Reactor Oversight Process Task Force FAQ Log – April 2, 2014

**Final NRC Response
FAQ 13-04
Point Beach Alert & Notification System**

**NRC Final Response
FAQ 13-05
Oyster Creek Downpower**

Attachment 1 - Reactor Power vs Time

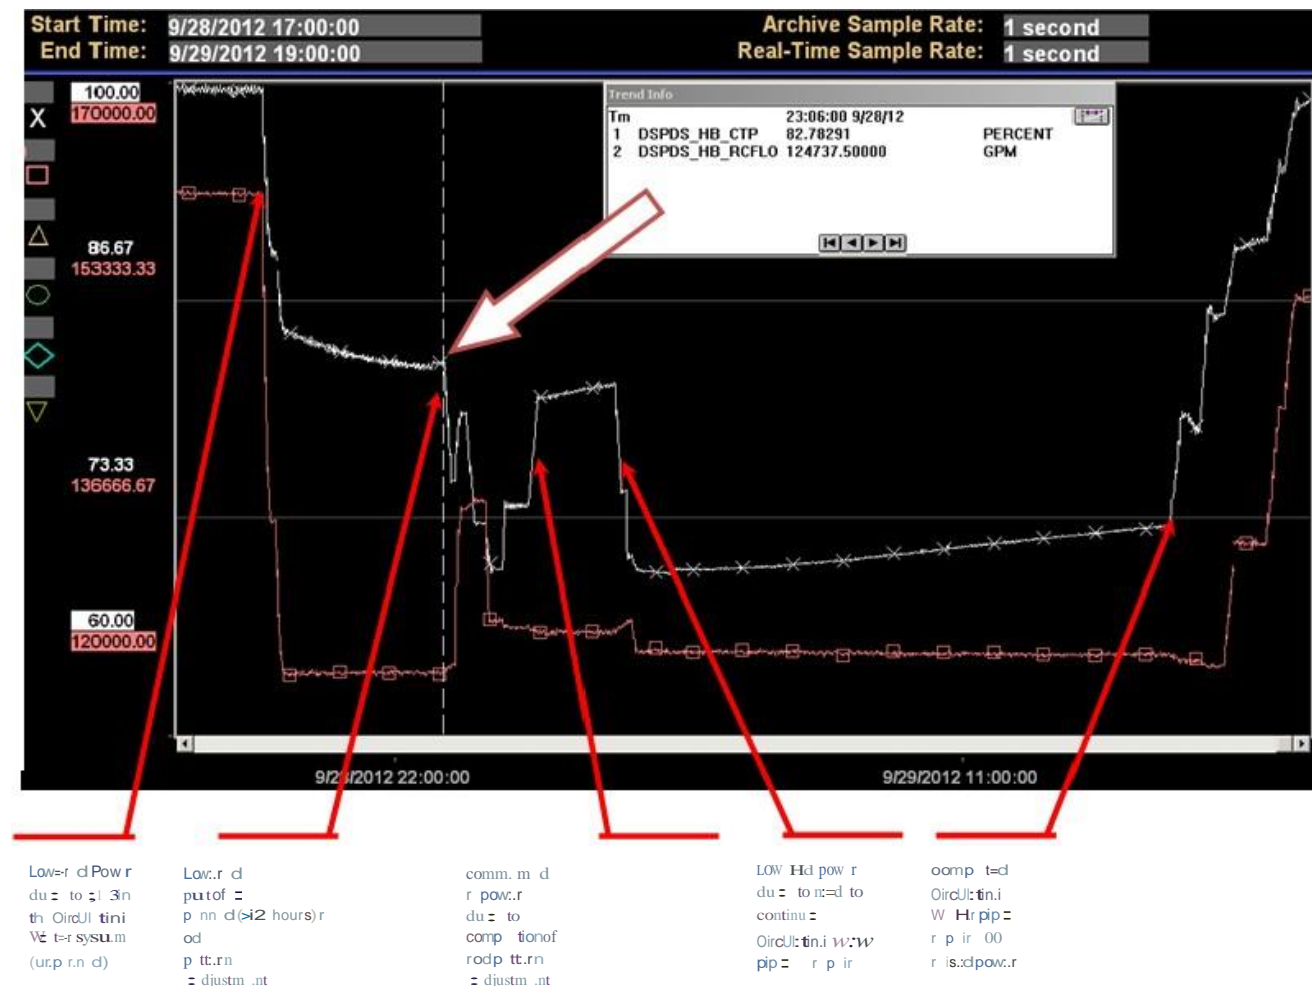
As noted above, Oyster Creek lowered power emergently (<72 hours) due to a salt water leak- with an initial power reduction to 85% (<20% reduction). Power was then lowered to 73% at 0015 in accordance with a planned (>72 hours) power maneuver. After completion of the planned power maneuver, during power ascension (at approximately 80%) a decision was made to lower power to 70% power to facilitate additional repairs to the circulating water system to attempt to eliminate leakage. 70% power was chosen to allow securing of a circulating water pump to increase repair options. (It is important to note that the repair could have been made at a power level above 70%.)

The NRC resident inspection staff determined that this downpower should count for the following reasons:

- The initial downpower was due to address an off-normal condition (the leak on the circulating water piping) and occurred approximately 4 hours before scheduled power reduction for control rod conditioning.
- The licensee reduced power by a total of 30% to perform the repair and resolve the equipment problem.
- The equipment problem was not repaired during the planned power reduction.

The NRC staff concludes that this event meets the first part of the definition of unplanned changes in reactor power since the down power was initiated less than 72 hours following the discovery of a circulating water leak and resulted in a total power reduction of 30% (100% to 70%) of full power to fully resolve.

The staff also concludes that the exclusion (NEI 99-02, Rev. 7, page 15, lines 15-17) does not apply to this event because the equipment problem (circulating water piping leak) **occurred prior to the scheduled activity and based on the specific circumstances of the event the equipment problem appeared to drive operators to lower power earlier than originally planned.** The staff's conclusion is that this event meets the guidance in NEI 99-02, Rev. 7, as an Unplanned Power Change per 7,000 Critical Hours performance indicator occurrence.

The emergent and preplanned power reduction should be evaluated as two power reductions as opposed to one continuous power reduction to 73%. The power reduction from 80 to 70 should not be counted as an unplanned power reduction since it was not >20% from the preplanned or the previous power level.
